Application by Equinor New Energy Limited for an Order granting Development Consent for the Sheringham and Dudgeon Extension Projects

Response to the following responses of to the ExA's WR2;

Submitted on behalf of Mr Clive Hay-Smith, Mr Paul Middleton and Priory Holdings Limited (refs: 20033312, 20032995 and 20033311)

Planning Inspectorate Reference: EN010109

Figure 1: taken from Application Land Plans (Sheet 3)

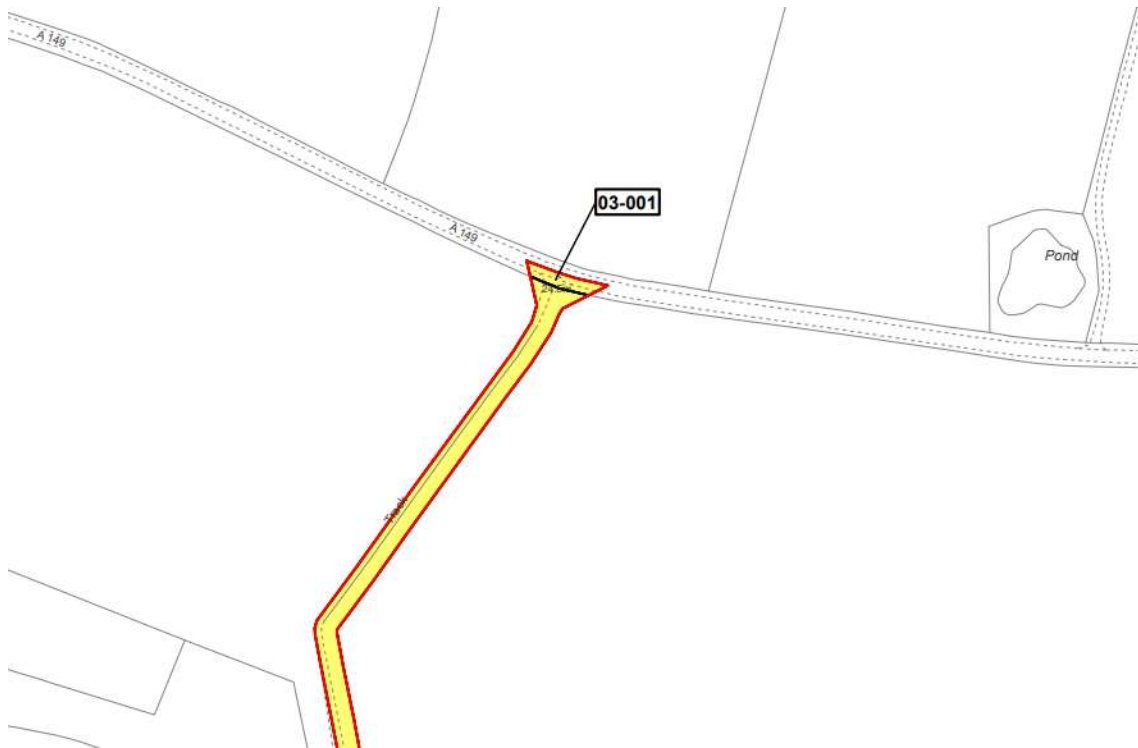
1. Our comments in relation to the ExA's WR2 and relevant responses relate to hedgerows on Mr Clive Hay-Smith's land which are in Order Limits for the purpose of Main Works Access (reference ACC05, BOR plot reference 03-002).
2. ACC05 is shown at Figure 1 below. It leads south from Sheringham Road (A149) outside Weybourne, and connects to Abbey Farm's main farm buildings complex. The importance of the track as a farm access is set out in the IP's Relevant and Written Representations, but in summary it is essential to Mr Hay-Smith and Mr Middleton's farm operations.

3. ACC05 comprises an unsurfaced single farm track. For the first 175 metres as it leads from Sheringham Road, the track is bounded on either side by a mature, mixed species hedgerow (the 'hedgerows'). A photo of part of the hedgerows is shown below at Figure 2. The width of the track between the hedgerows is four metres. The aggregate length of the hedgerows is 350 metres.

9. HGV vehicles are up to a maximum 2.9 metres in width, and it is reasonable to assume HGVs of such dimensions will be used for the development (we have been unable to find any reference in the ES). This leaves no room for error for HGV construction traffic straying off a three metre corridor in order to avoid straying into the RPZ with associated damage to the hedgerows' roots. In practice we consider it is inevitable that over the course of the construction programme that HGVs and LVs will stray into the RPZ and that cumulatively that damage will be done to the hedgerows.

14. The risk of harm is nevertheless avoidable; Mr Hay-Smith has proposed to the Applicant they adopt an alternative access route, to the immediate east of west or ACC05 for the first 175 metres leading from Sheringham Road, but with sufficient separation from the hedgerow to prevent harm. There would be no operational disadvantage to adopting such a variation.
